2000-3 Arapaho Road  
Southwestern Bell Relocate Utilities - 1999

Re: Arapaho Rd / Spectrum Drive

Re: Permit for Telephone Service – DART Transit Center

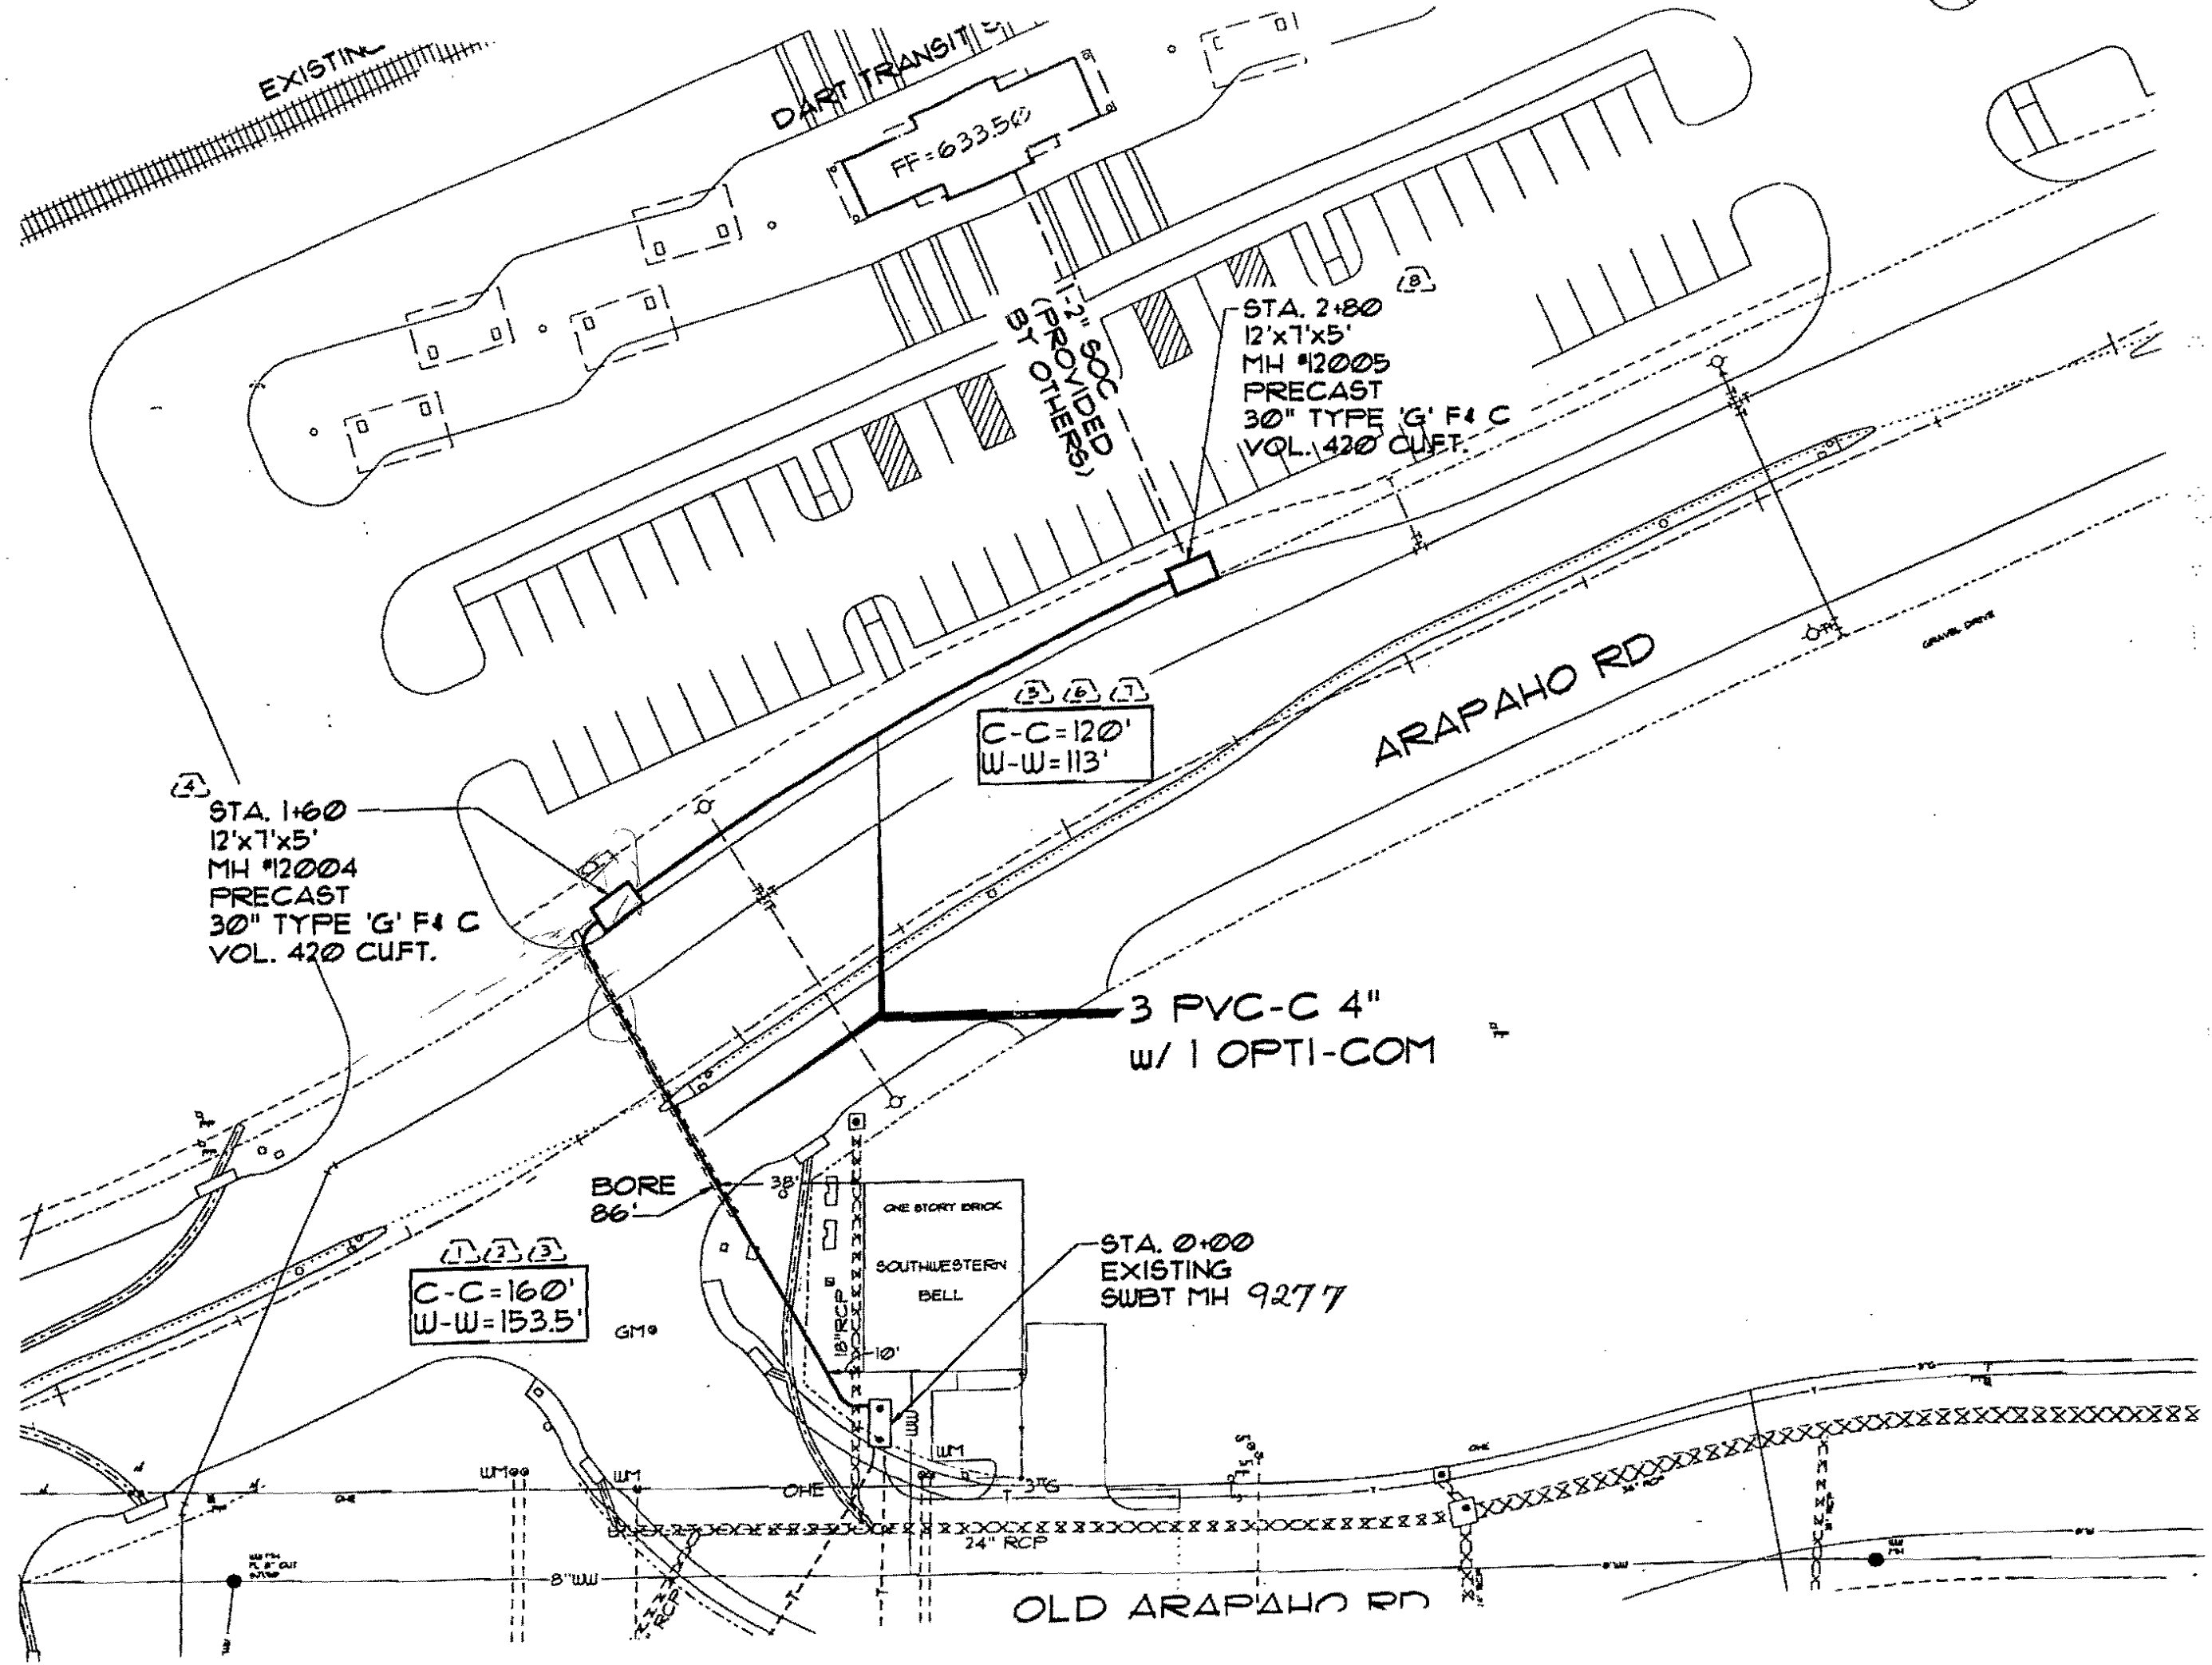
"Cut around" is done @ Can America

Cables may be in the ducts,

but the "cut around" is complete.

OK to go ahead and wreck  
the upper duct.

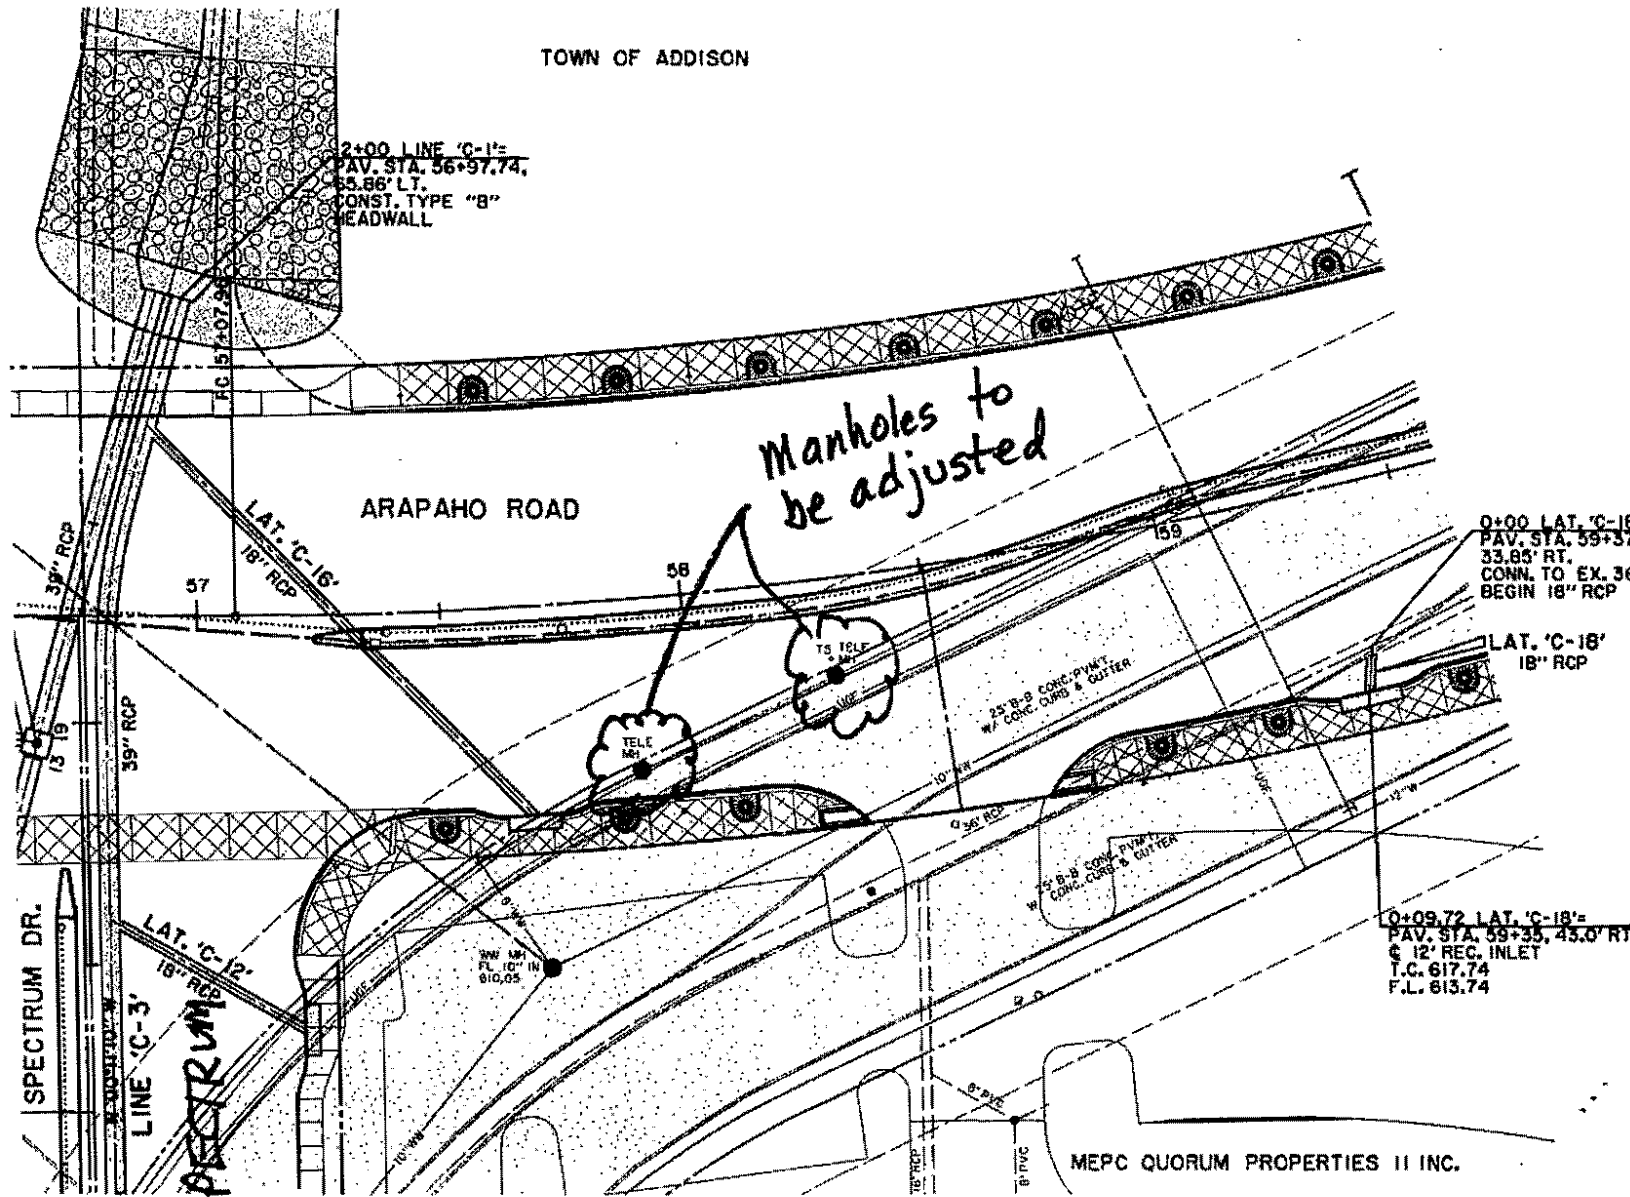
Manholes to  
be adjusted

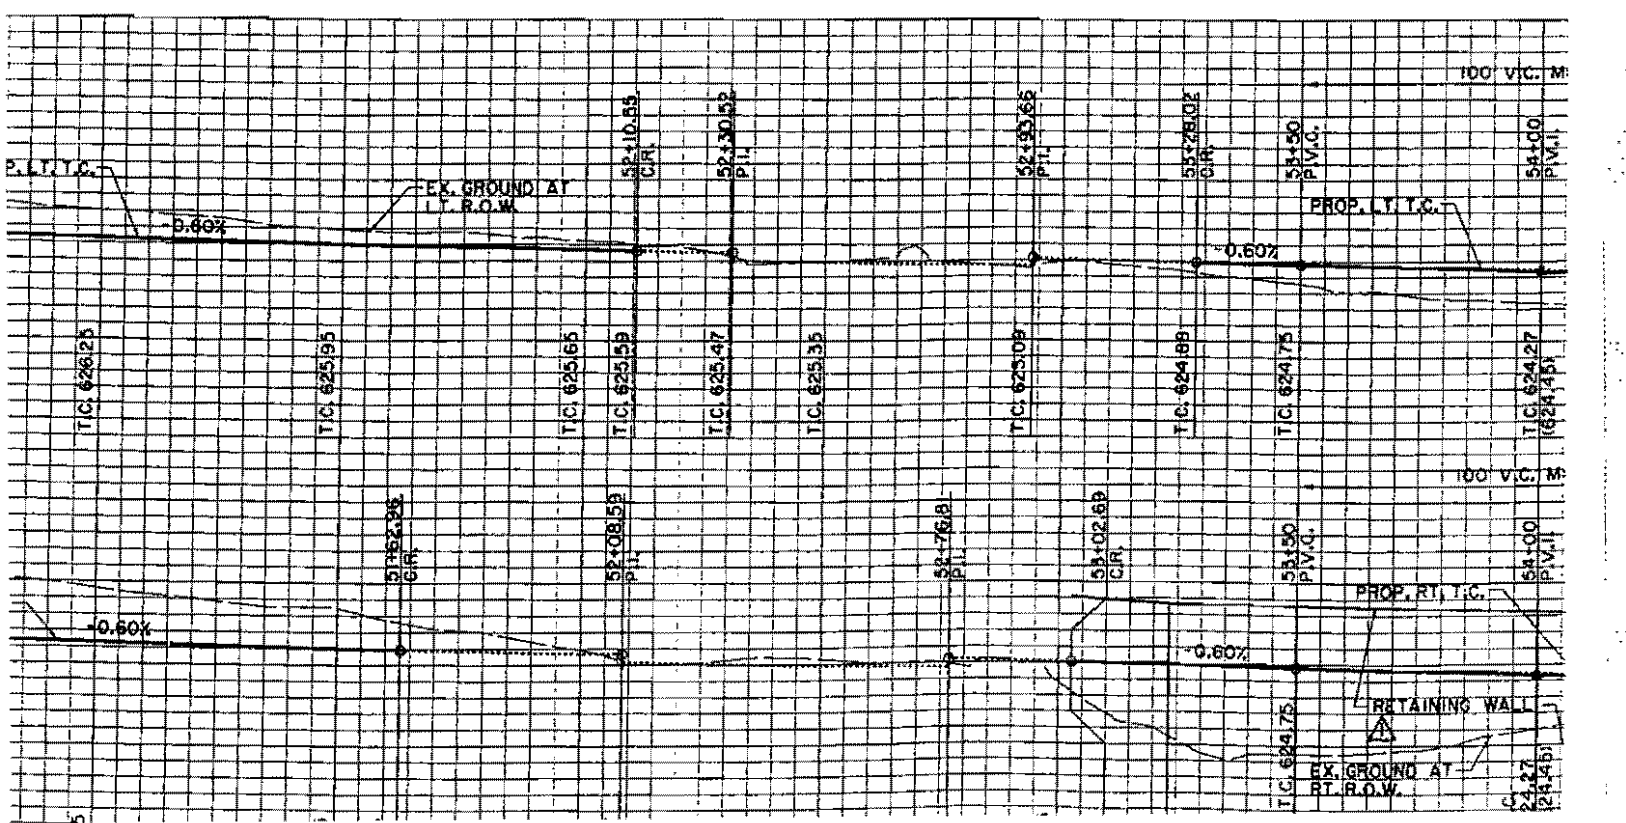
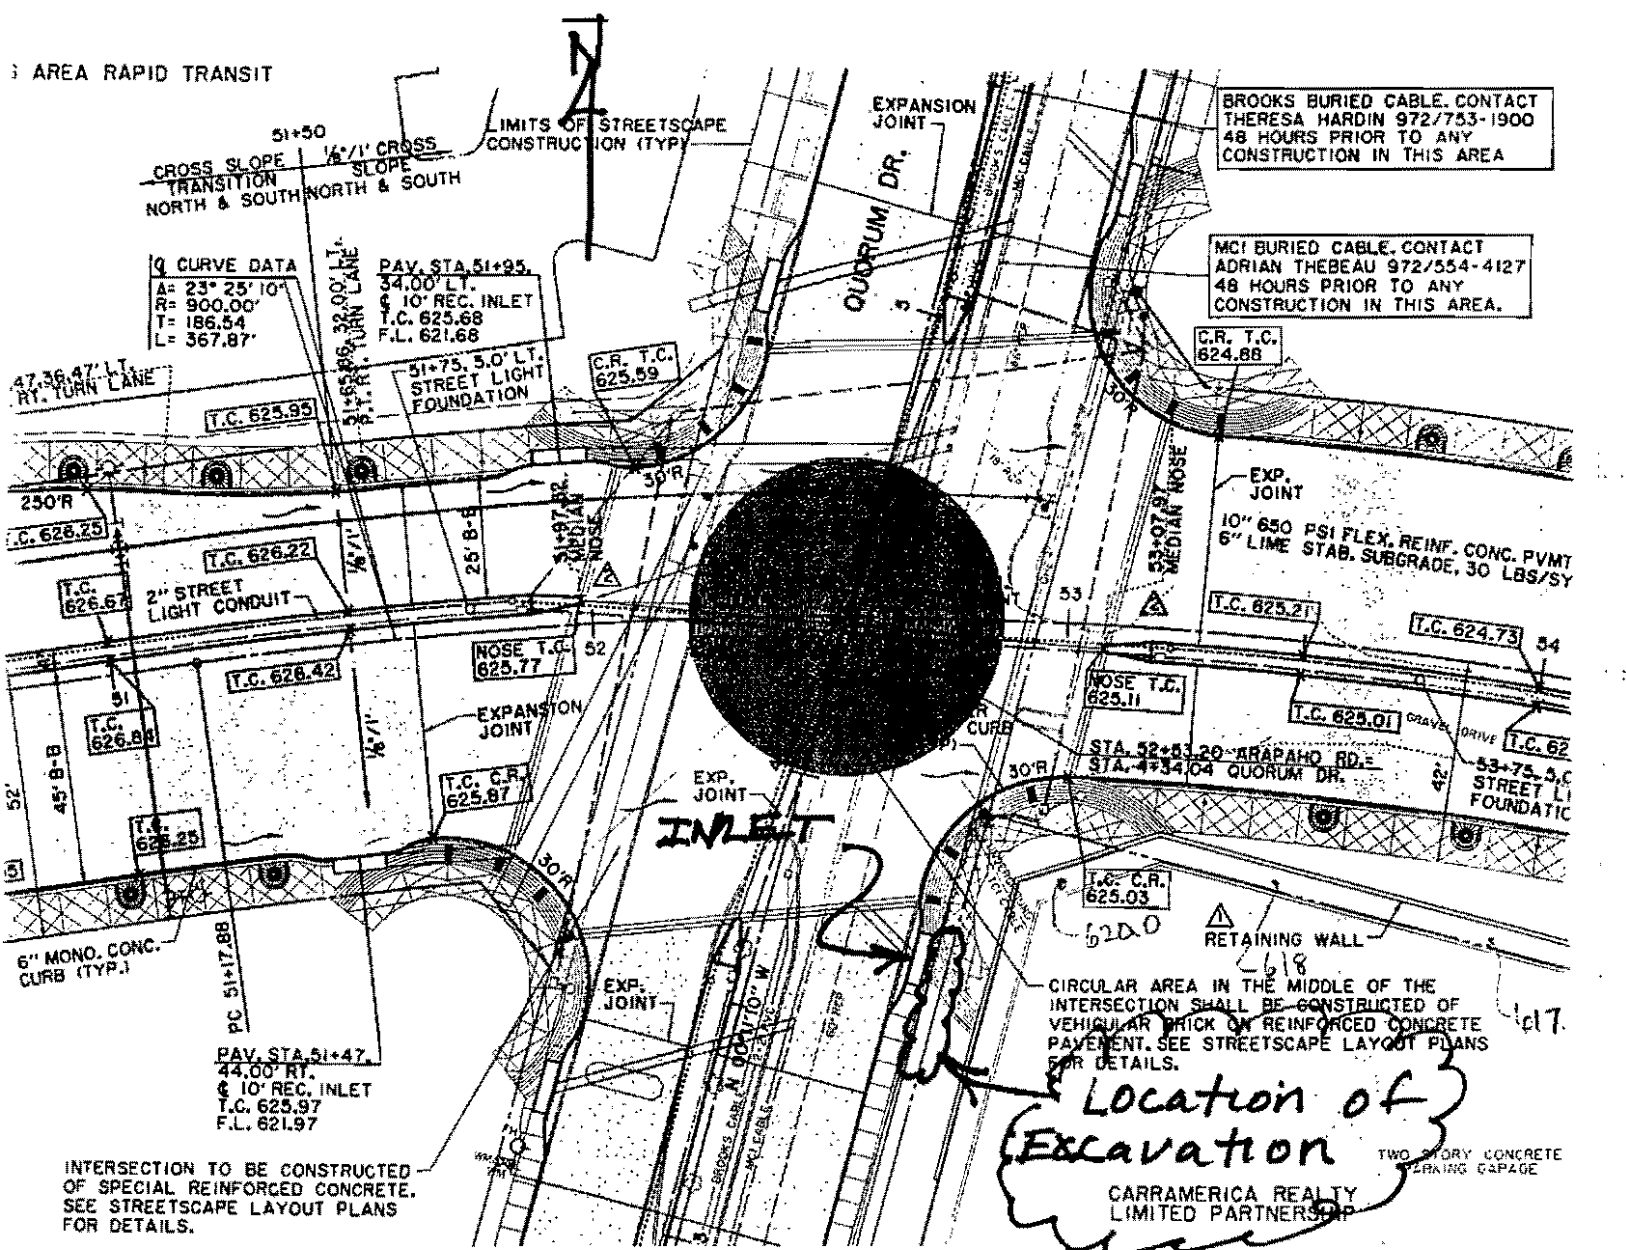
Comments: TU, in the process of setting a pole,  
cut one of your cables @ the S.E. corner  
of Quorum Drive and new Arapaho Rd. To  
repair the cable, SW Bell excavated to gain  
access to the underground cable, and in the  
process, excavated such that an adjacent  
inlet has little support from the earth  
supporting it. I am concerned that the inlet  
will be damaged. The best fix is to  
get in & make the repair & backfill & compact.  
Second best is to partially backfill &  
compact the hole to protect the inlet <sup>until repairs</sup> are made.  
See attached for location. Please call  
if you have any questions.

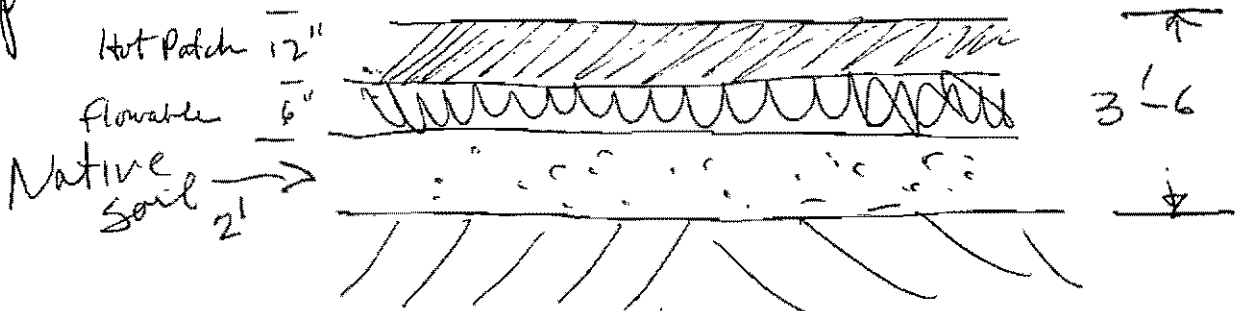
3'-6" depth, hit hard rock. Backfill flowable to 3'-6" depth.

Native soil 95% compact - Not under rd

Under Road 2' native @ 95%

12" Hot patch
